Tesla, Inc.
Service Bulletin

Replace Suspension Components

SB-25-31-005
May 8, 2026

Figure 1

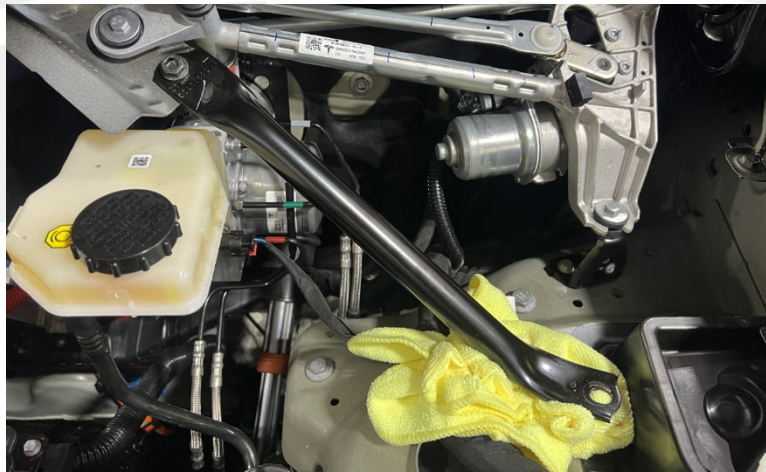
- If the rattling or knocking noise is present, continue to the next step.
 - If the rattling or knocking noise is not present or a different noise is heard, discontinue this procedure and use correction code S022531005.
2. Remove the bolts (x2, 13 mm) from the LH and RH wiper bracket pencil brace lower attachment points and swing the arms away from the bolted flanges, then wedge a shop towel between each of the braces and mounts to isolate the lower attachment points (Figure 1).
